Addendum 6: Regulation No. 7

Revision 5 – Amendment 2

Supplement 17 to the 02 series of amendments: Date of entry into force: 30 January 2011

Uniform provisions concerning the approval of front and rear position lamps, stop-lamps and end-outline marker lamps for motor vehicles (except motor cycles) and their trailers

Front End-outline marker lamp
(AM)

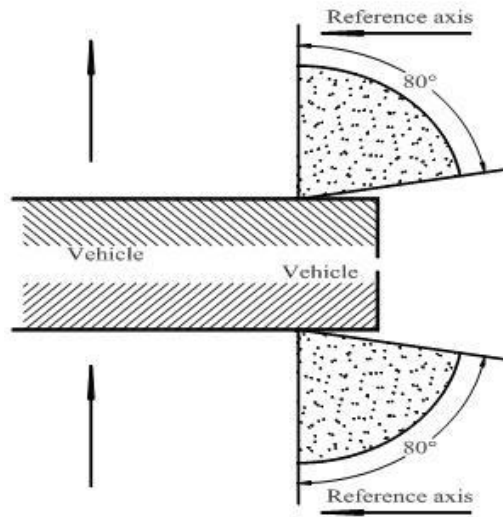
Annex 1, amend to read:

"Front and rear position lamps, end-outline marker lamps and stop-lamps: minimum angles required for light distribution in space¹
